Reindeer Project Construction Services, Savoonga **EDA Project Number 07 79 07873**

Addendum #4 **7/17/2024**

Summary of items included in this addendum:

CORRAL SITE PLAN

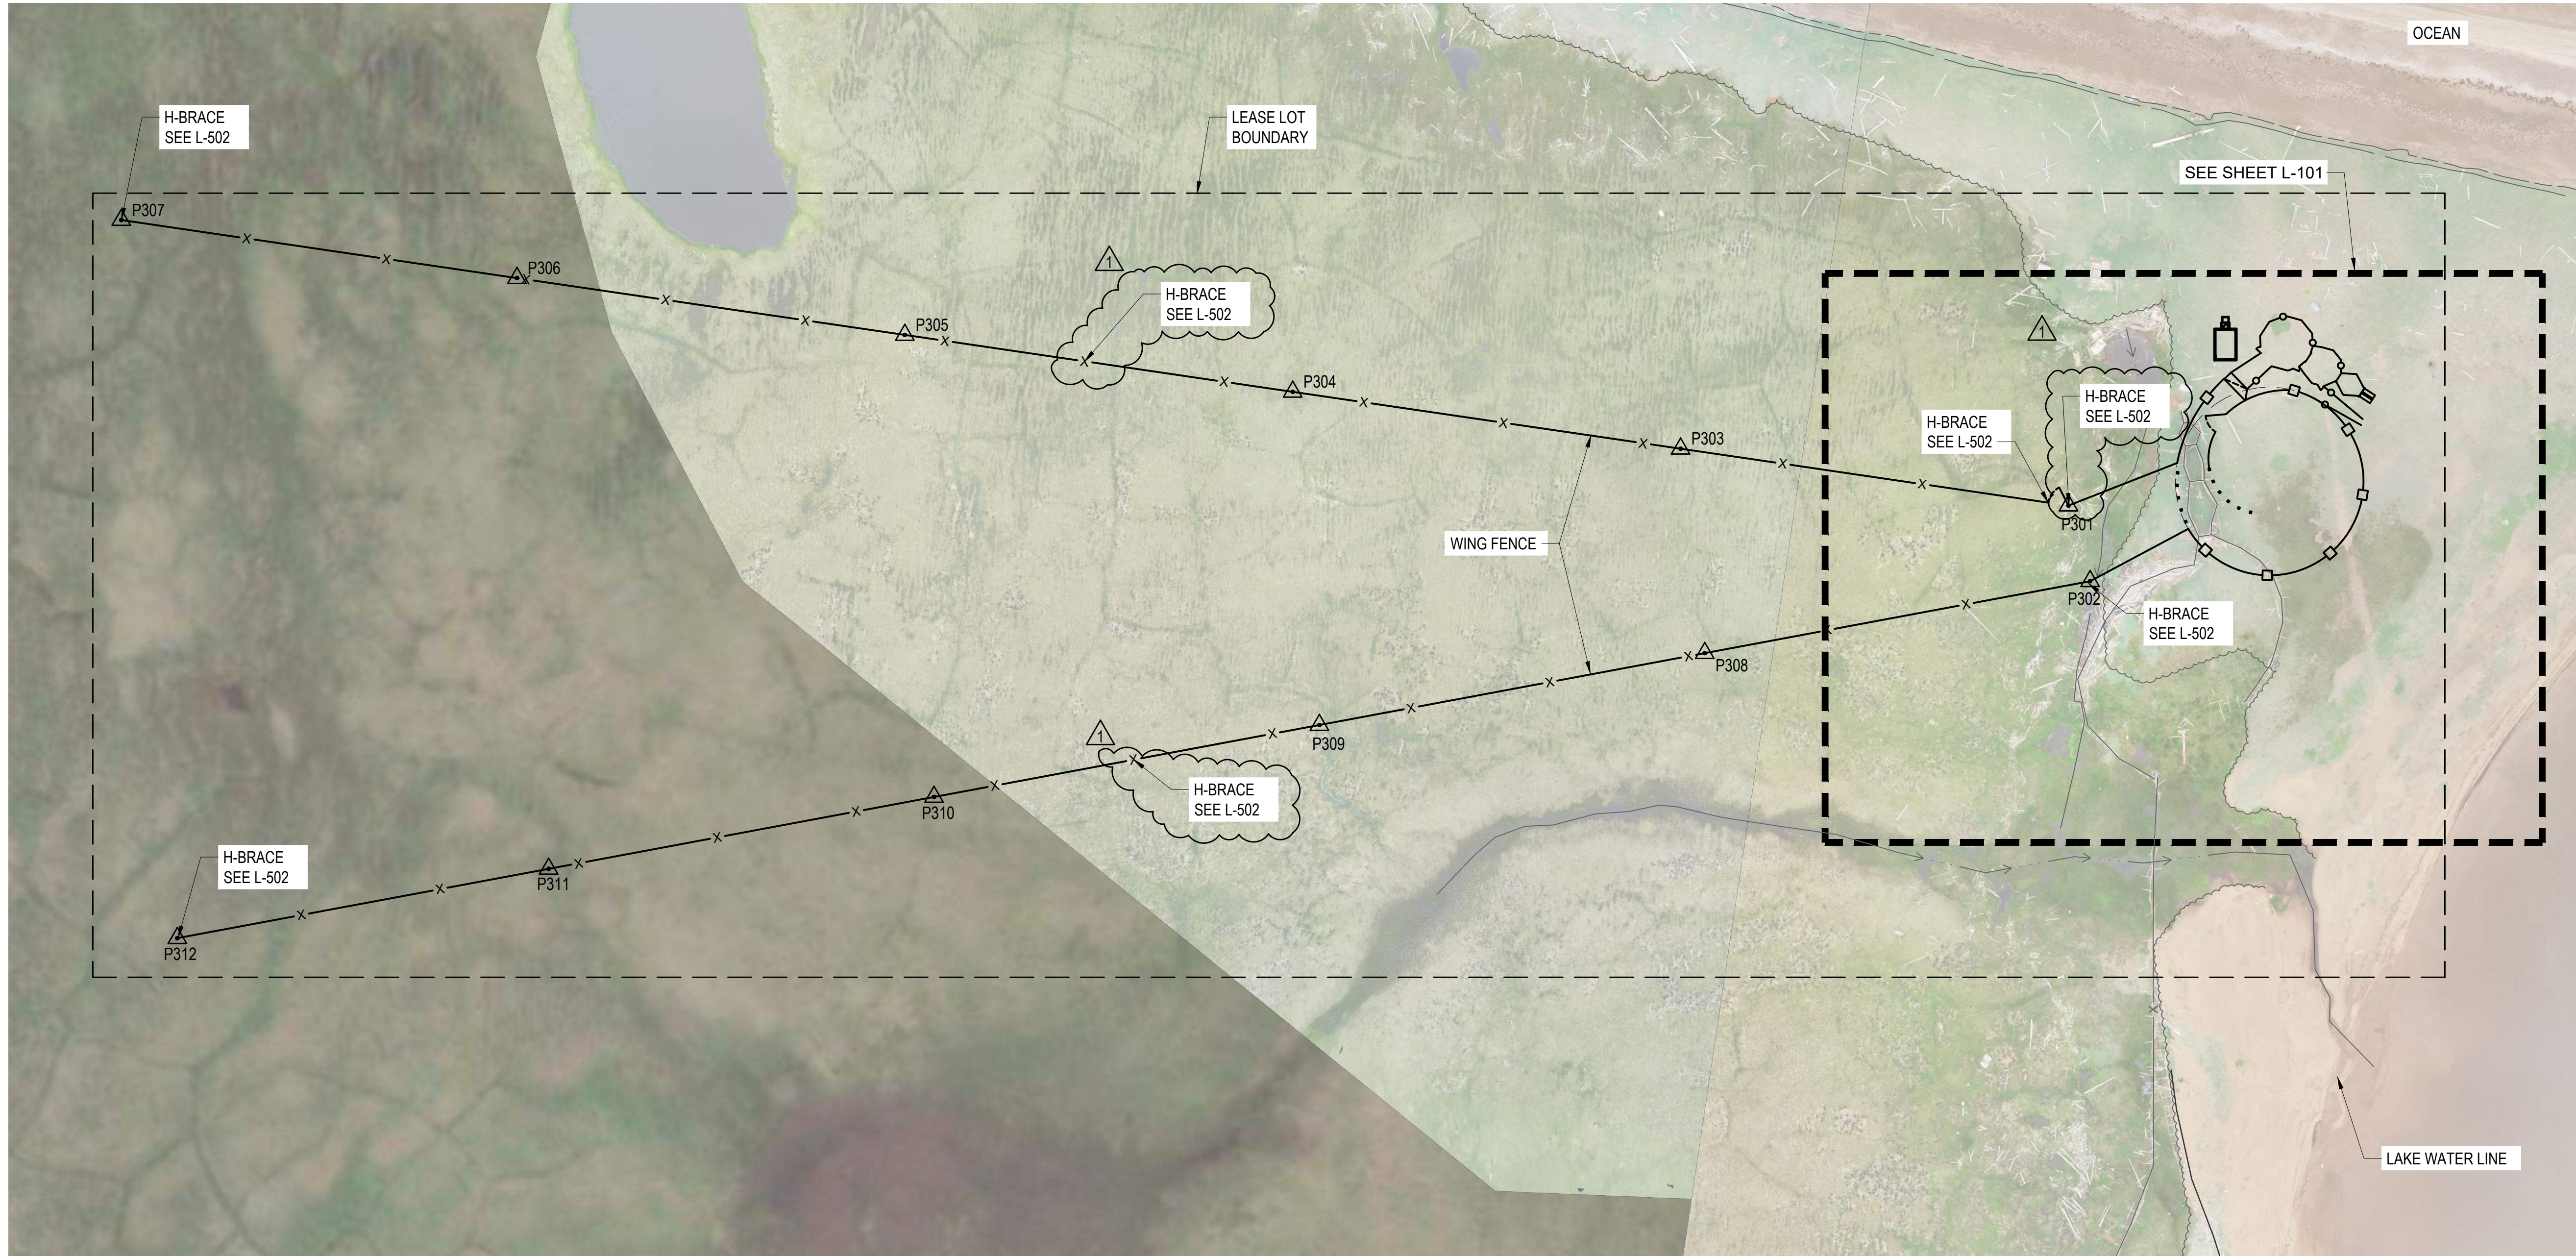
- CONSTRUCTION ACTIVITIES SHALL OCCUR ON SAND, NOT TUNDRA.
- THE CORRAL SUPPORT BUILDING IS UNOCCUPIED AND UNHEATED.
- CONTRACTOR SHALL RESTORE ALL DISTURBED AREAS WITH SEED MIX TYPE A.
- SEED MIX TYPE A SHALL BE: 50% NORTAN TUFTED HAIRGRASS, 25% BOREAL RED FESCUE, 20% GRUENING ALPINE BLUE, 5% ANNUAL RYE. APPLY AT 3 LBS PER 1,000 S.F.
- PRIOR TO CONSTRUCTION, CONTRACTOR SHALL FIELD VERIFY ALL H-BRACE CONDITIONS. CONTRACTOR SHALL INSTALL ALL H-BRACING PER SHEET L-502

ENLARGED CORRAL SITE PLAN
SCALE: 1" = 20'-0"

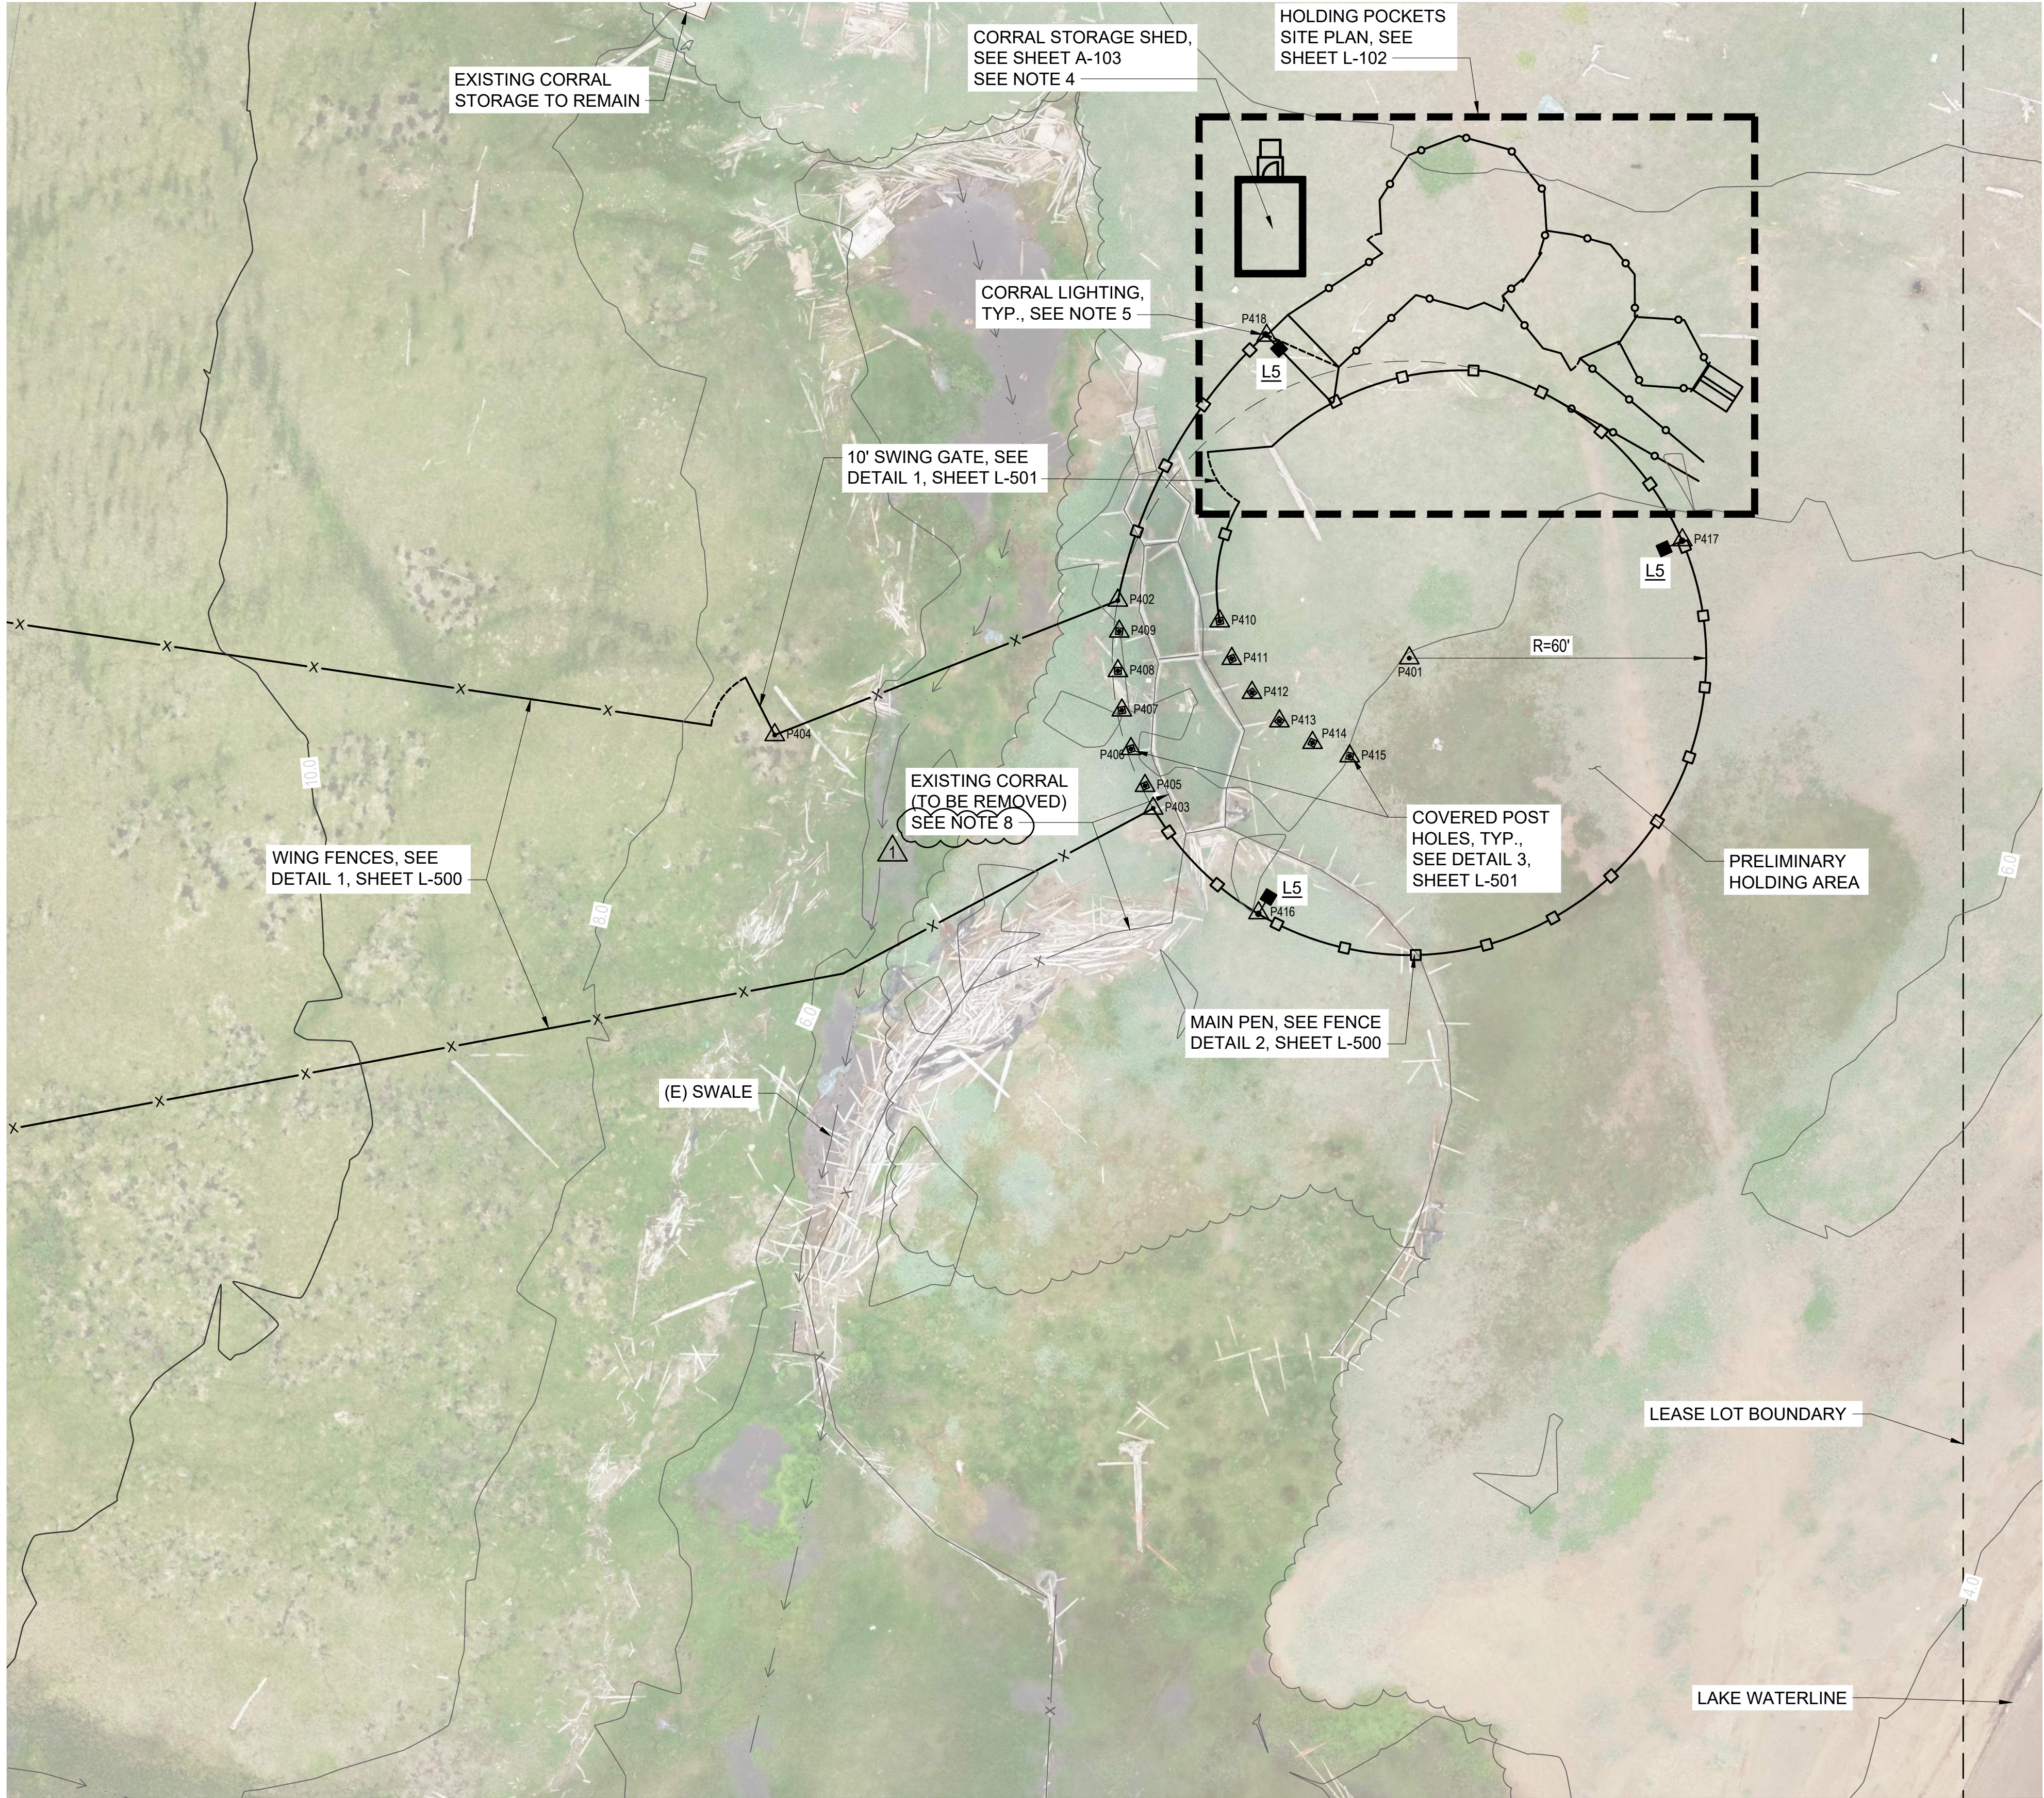
- WOOD POLES FOR CORRAL LIGHTING SHALL BE 30' LONG (TREATED UTILITY) POLES WITH 10' DEPTH OF BURY.
- CONTRACTOR SHALL RESTORE ALL DISTURBED AREAS WITH SEED MIX TYPE A. SEE SHEET C-101 NOTE 3

- ALL EXISTING CORRAL MATERIAL REMOVED FOR THE PROJECT SHALL BE ORGANIZED AND STACKED NEATLY ON THE WEST SIDE OF THE CORRAL SUPPORT BUILDING
